UNITED STATES DEPARTMENT OF COMMERCE United States Patent and Trademark Office Address: COMMISSIONER FOR PATENTS P.O. Box 1450 Alexandria, Virginia 22313-1450 www.uspto.gov

APPLICATION NO.	FILING DATE	FIRST NAMED INVENTOR	ATTORNEY DOCKET NO.	CONFIRMATION NO.
10/581,616	10/19/2006	Nathalie Bergeret	0549-1018	5414
466 YOUNG & TH	7590 02/10/201 OMPSON	EXAMINER		
209 Madison St		BODAWALA, DIMPLE N		
	Suite 500 Alexandria, VA 22314			PAPER NUMBER
			1743	
			NOTIFICATION DATE	DELIVERY MODE
			02/10/2011	ELECTRONIC

Application No.	Applicant(s)			
Office Astion Commence	10/581,616	BERGERET, NATHALIE			
Office Action Summary	Examiner	Art Unit			
	DIMPLE BODAWALA	1743			
The MAILING DATE of this communication app Period for Reply	pears on the cover sheet with the c	orrespondence address			
A SHORTENED STATUTORY PERIOD FOR REPL' WHICHEVER IS LONGER, FROM THE MAILING D  - Extensions of time may be available under the provisions of 37 CFR 1.1 after SIX (6) MONTHS from the mailing date of this communication.  - If NO period for reply is specified above, the maximum statutory period - Failure to reply within the set or extended period for reply will, by statute Any reply received by the Office

Above figure is cross sectional view of mould as shown in figure 1 of RADE ('569)

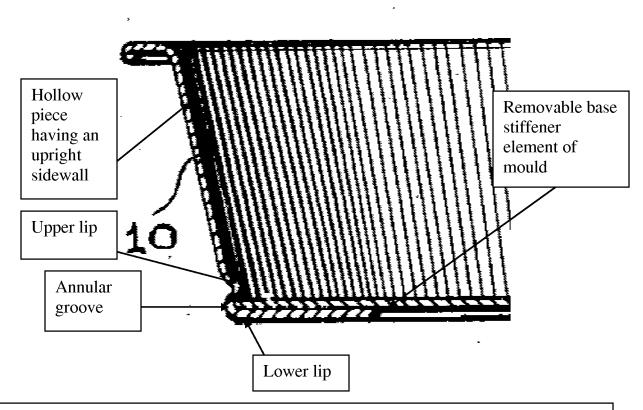
- 15. As to claims 38, 57, RADE ('569) discloses one-piece construction of hollow piece of cake pan as a mould which surrounds a removable rigid plate-shaped base stiffener (13) (See Page 1, lines 57-61; fig. 1). Figure 1 of RADE ('569) clearly shows that an annular continuous upright sidewall (10) having a lower portion, wherein the lower portion comprising an inturned flange (12) at its lower edge of the upright sidewall (See Page 1, lines 55-56), wherein such flange (12) enable to hold and support the bottom plate (13) and defining with the plate shaped base stiffener a bottom wall of the mold, thus such configuration of flange (12) enable to define a lower lip of mould as claimed. Figure 1 of RADE ('569) further shows that there is a feature projected from the lower base of the upright sidewall and extending above the lower lip (12), and define an annular groove there between, wherein the annular groove is equipped with bottom plate

such that the upper lip of the wall pinning the plate and thus base plate securely disposed therein (See figure 1).

enable to exhibit the mould with excellent properties such as flexibility, durability, strength, etc., see In re Fout, 675 F.2d 297, 213 USPQ 532 (CCPA 1982); In re O'Farrell, 853 F.2d 894, 7 USPQ2d 1673 (fed. Cir.1988); Ruiz v. Chance Co., 357 F.3d 1270, 69 USPQ2d1686 (Fed. Cir. 2004). It is not necessary that the prior art suggests expressly or in so many words the changes or possible improvements the inventor made but that the knowledge is clearly present. In re Sernaker, 217 USPQ 1 (Fed. Cir. 1983). 19. As to claims 39-40, RADE ('569) further teaches that the lower base of the side wall (10) is formed integrally with the lower lip (12), wherein the lower lip (12) is a continuous lip (See figure 1).

20. As to claims 41-43, Figure 1 of RADE ('569) further shows that the lower lip (12) is a lower ring-shaped wall limited towards the center of the bottom wall by a hole that is

covered by the plate shaped base stiffener (13). Figure 1 of RADE ('569) further shows that the lower ring-shaped wall occupies some area of the total surface area of the bottom wall of the mould, but fails to provide ranges as cited in claims 42-43. So, it would have been obvious to one of ordinary skill in the art at the time of Applicant's invention to modify the invention of **RADE** ('569) by optimizing range of the total surface area of the plate shaped base stiffener covered by the lower ring shaped wall, wherein such configuration of the mould allowed the user to slide and/or clip the plate shaped base stiffener easily on the lower ring-shaped wall, and, thus, lower ring-shaped wall retains the plate shaped base stiffener during the various applications.

- 21. As to claims 45-47, RADE ('569) further teaches that the length of the extension of the lower lip from the lower base of the side wall and the length of the upper lip (See figure 1), but fails to provide ratio between these two lengths. It would have been obvious to one of ordinary skill in the art at the time of Applicant's invention to modify the invention of **RADE** ('569) by optimizing ratio of the length of the extension of the lower bead from the lower base of the side wall to the length of the upper bead in desired range and/or as cited in the claim, in order to define dimension of lower ring shaped wall, so the user enable to slide and/or clip the plate shaped base stiffener easily on the lower ringshaped wall, and, thus, lower ring-shaped wall retains the plate shaped base stiffener during the various applications.

- 22. As to claim 48, RADE ('569) further teaches that the mould comprises an upper lip is a continuous lip (See figures 1-2).
- 23. As to claims 49-51, RADE ('569) discloses mould having a lower portion which define an upper lip (not labeled but see figure above with label), wherein upper lip having a single segment (See figure 1-2), but fails to teach or suggest that upper lip having several segments as cited in claims of the instant application. So it would have been obvious to one of ordinary skill in the art at the time of Applicant's invention to modify the segment of upper lip of lower portion of hollow piece mould of **RADE** ('569), in

24. As to claim 56, RADE ('569) further teaches that the plate shaped base stiffener (13) is clipped into the groove (See figure 1).
